**PREPARED FOR THE BOARD OF COMMISSIONERS OF PUBLIC UTILITIES OF  
NEWFOUNDLAND AND LABRADOR**

In response to Newfoundland Labrador  
Hydro's 2025 "Application for Capital  
Expenditures for the Purchase and Installation  
of Bay d'Espoir Unit 8 and Avalon  
Combustion Turbine"

**EXPERT REPORT OF VINCENT MUSCO AND COLLIN CAIN**

**February 3, 2026**

Figure 3-11 Long Pond Inflows Jan 1 to Feb 11 in the 2025 Prolonged LIL Outage model [18]

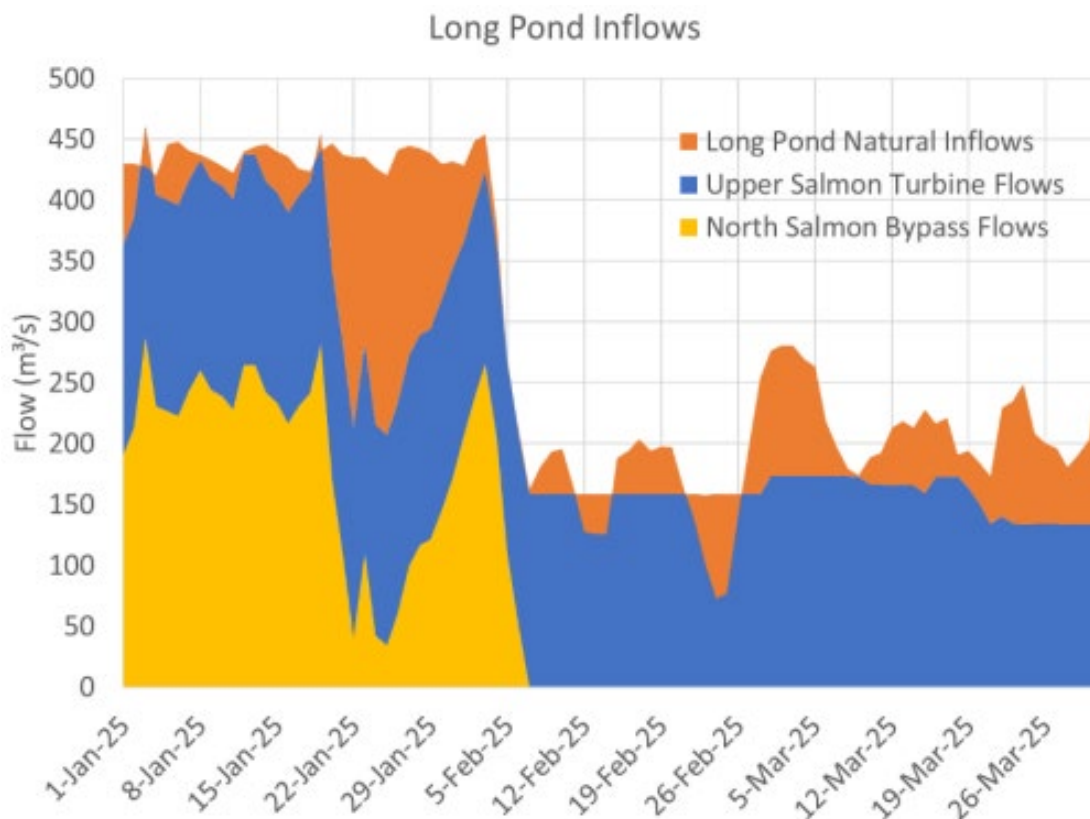
- > As can be seen in Figure 3-11 the increased inflow between January 21st and 25th relieves the flow over the Upper Salmon Spillway during that period. This raises the question of whether the higher bypass flow of approximately 250 m<sup>3</sup>/s could have been maintained for the full 6 week LIL outage.

- > Even with the high flows in late January the North Salmon Spillway is actively in use with flows between 50-300m<sup>3</sup>/s (taken from Figure 3-11) over the full 6 week period (11.5% of the year). This lies in sharp contrast to the studies discussed in Section 3.3.1 which found the bypass spillway to be used "3% of the time with the addition of unit 8" ([2] page v), and in Section 3.3.4 which found that " No spilling past the Upper Salmon plant was needed during these outages in 2024 or 2032" ( [17] Section 4 p.29). This disparity between the findings of these three studies in the matter of the use of the spillways makes the conclusion of this

Figure 5-2: Monte-Carlo distribution for Estimating Management Reserve[4].

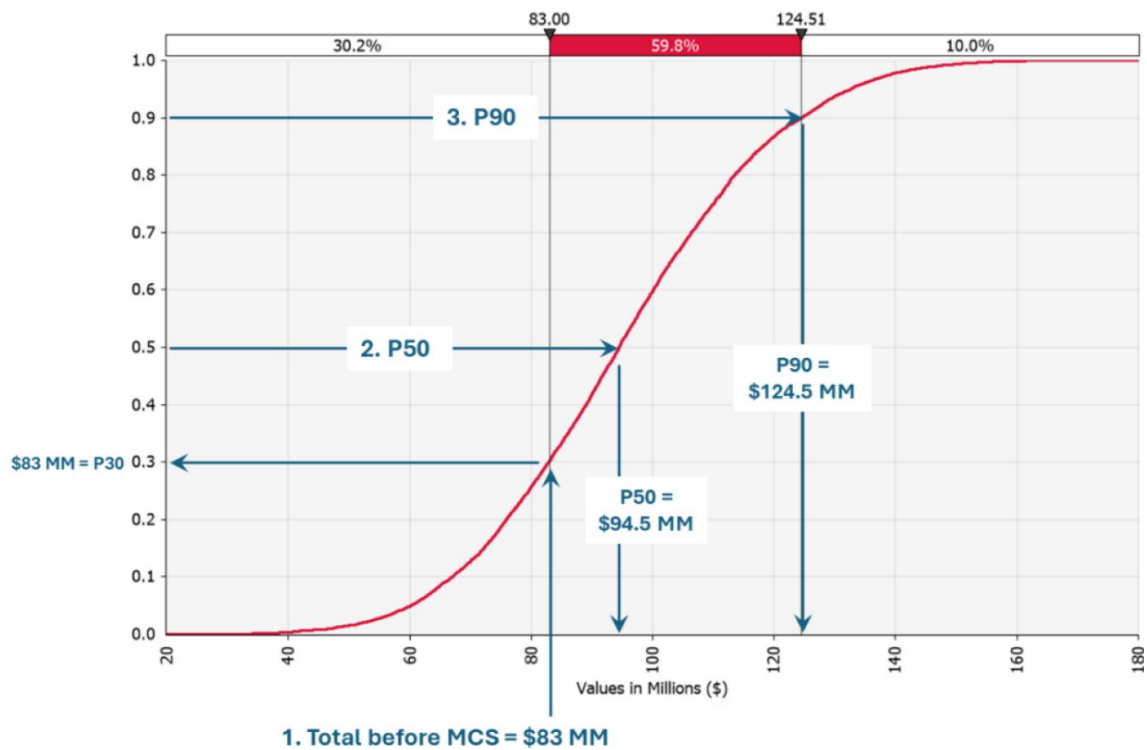
Although the utility's approach appears sufficiently described thorough for the project, it is not clear where the probabilities of adverse events for each project element are presented. For transparency and effective sense-checking, it would be helpful if the utility provided the contingency and management Reserve results for the P85 scenario broken down by work package (CWA 1 to CWP 3.1). This would allow the financial risks associated with each work package to be compared directly with its estimated value.

Figure 6-4 Sample penstock excavation / filling section

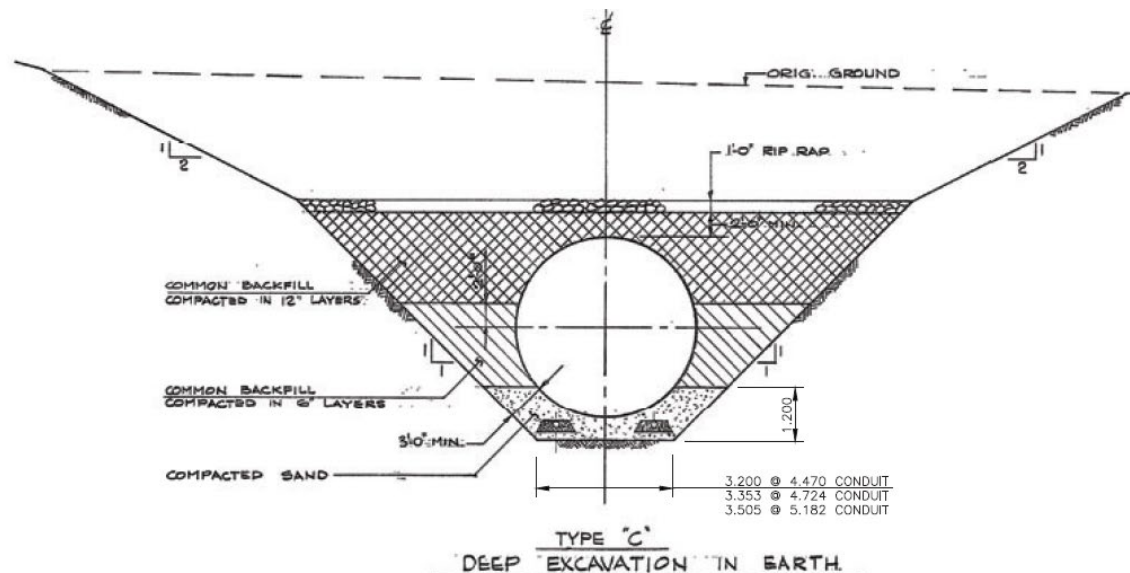
- > The penstock drawings indicate that a riprap layer, 30 cm in thickness, will be installed as the topmost layer, as illustrated in the figure below. However, the placement of large riprap rocks over the penstock may result in unforeseen consequences, such as ovalization of the penstock or potential damage to the protective layers. It is essential to implement necessary precautions, and the layering process above the penstock section must be executed with meticulous care.

Figure 7-2 Powerhouse sectional view

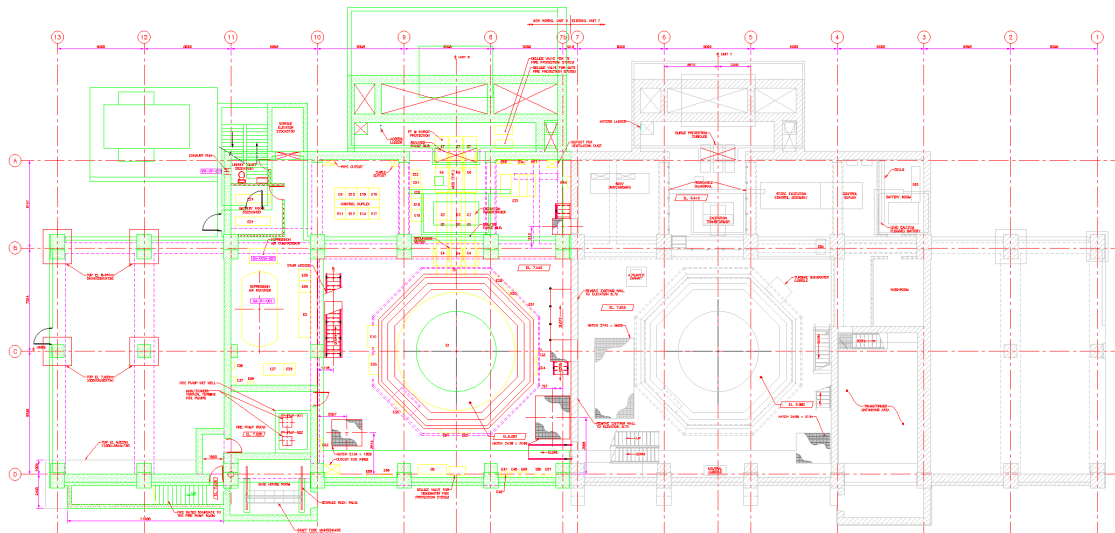
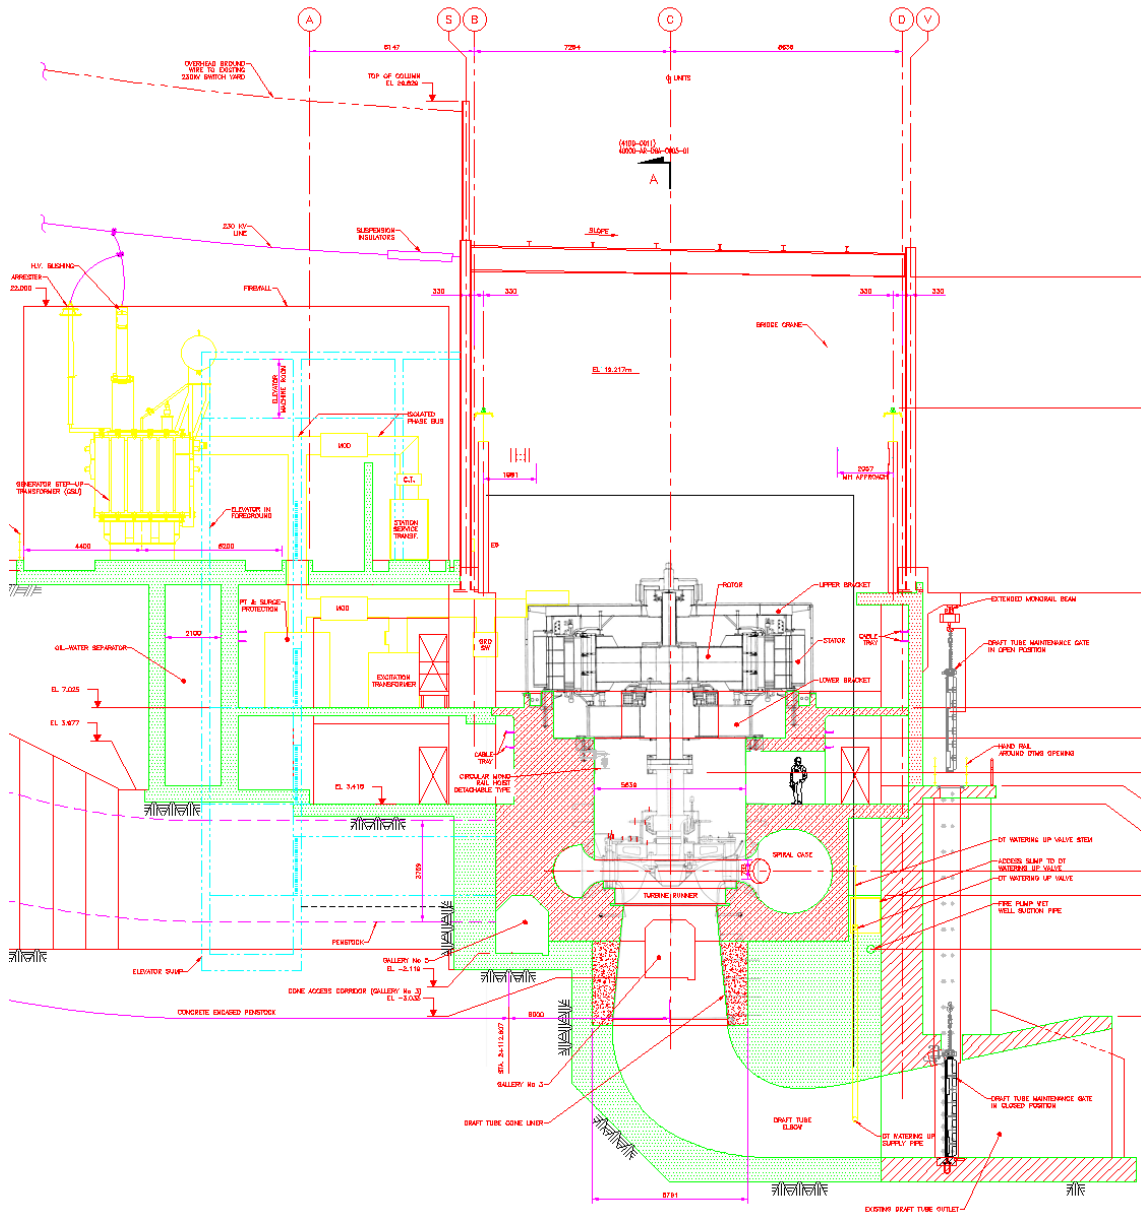
- > The following optimisations are suggested with the aim of reducing costs, as they are redundant:
  - An existing erection bay is available for Unit 7; therefore, a dedicated erection bay for the planned Unit 8 may not be required, and the planned Unit 8 erection bay should be cancelled, subject to confirmation that lifting capacity, access clearances, and schedule logistics are satisfactorily met using the Unit 7 facility.
  - The previous powerhouse unit (Unit 7) operated without an elevator; accordingly, the elevator for the new Unit 8 may be omitted, provided that regulatory and safety requirements are met.
